# Recall Notice

**Recall #: R000003**

Inform Aluma dealers and owners that 8605T, 8610T and 8612T trailers may have misaligned welds that may contribute to a failure of the trailer's axle mount weldment.

Figure 1

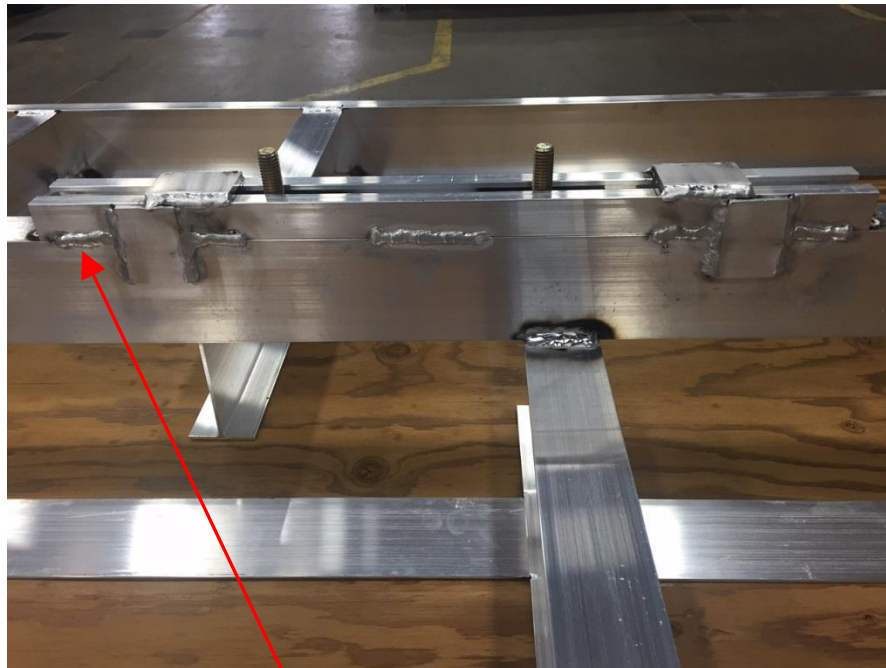
- 2.0 Remove and secure tires and hardware to be reinstalled later in step 8.
- 3.0 Inspect inside weld joint of axle mounts and U-channels for misalignment of weld or any cracks in welds. See Figure 1. If any defects are present proceed to inspecting axle mount outside welds and verify that there are no signs of base material damage. Repair all suspect welds using step 6. See Figures 3 and 4.

Option 1: flat strap configuration.  
Inspect location of weld in joint.

- 4.0 Add flat strap to inside of axle mount as shown in Figure 1 and 2. Depending on condition of welds found in steps 5 or 6.
  - 4.1 Option 1: Flat strap must be located 2 inches from end of axle mount if flat strap can be placed flat onto axle mount and U-channel and then weld.
